BEFORE THE PUBLIC UTILITIES COMMISSION  
OF THE STATE OF HAWAII

----- In the Matter of ----- )  
 )  
PUBLIC UTILITIES COMMISSION ) DOCKET NO. 2018-0165  
 )  
Instituting a Proceeding )  
To Investigate Integrated )  
Grid Planning. )  
\_\_\_\_\_ )

ORDER NO. 38482

APPROVING WITH MODIFICATIONS  
HAWAIIAN ELECTRIC'S GRID NEEDS ASSESSMENT

<sup>139</sup>Figure adapted from Grid Needs Assessment Methodology, Exhibit 4 at 18, Figure 6.

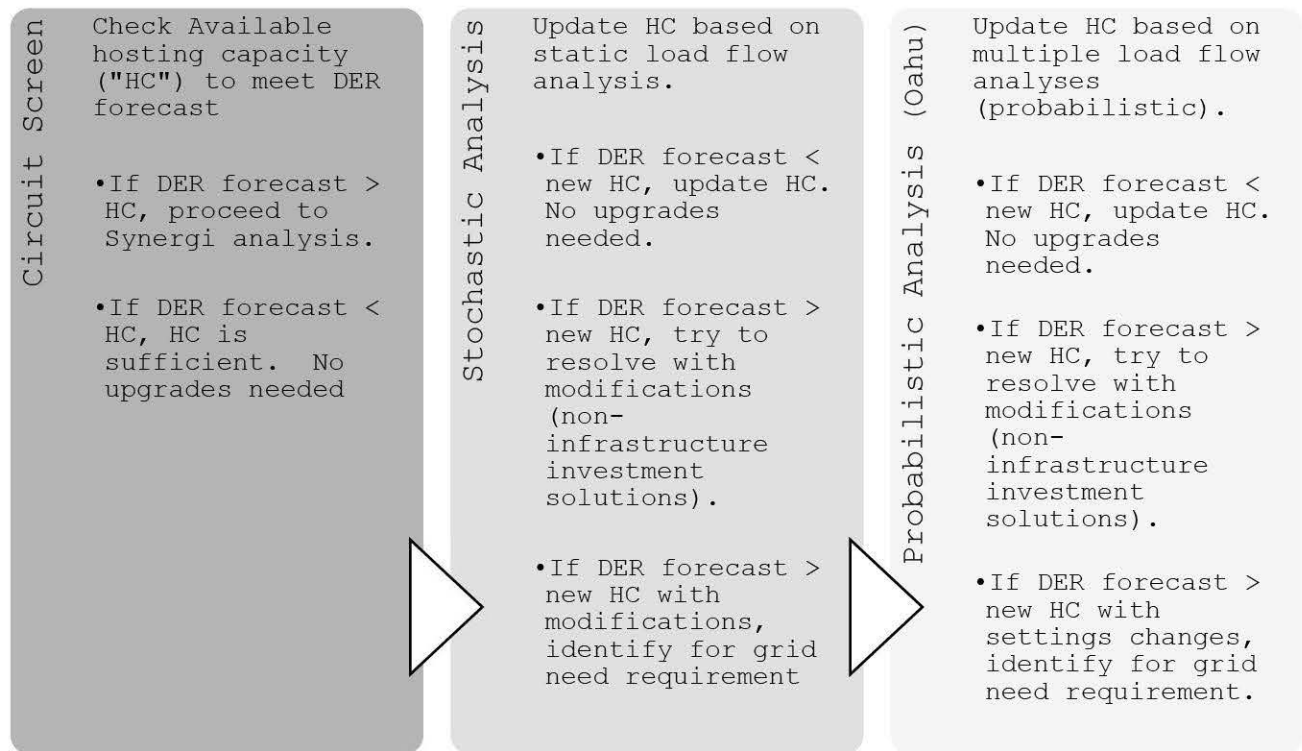
Further development of the hosting capacity analysis in the Distribution Planning Process will aid in determining and mitigating future hosting capacity violations. This iterative process for determining hosting capacity based on in-depth stochastic and probabilistic analyses will allow Hawaiian Electric to resolve grid deficiencies more holistically with non-infrastructure investment solutions. The process will also

enable DER growth across Hawaiian Electric's service territories as the State and Hawaiian Electric rapidly pursue decarbonization and resilience goals. Therefore, the Commission approves this methodology for this round of IGP. The Commission notes that the approval of this methodology as part of this Review Point is for use within the IGP process and should not be construed as approval for general use in other dockets, as Hawaiian Electric is updating its existing hosting capacity methodology to account for all hours in its Distribution Planning Methodology.<sup>140</sup>
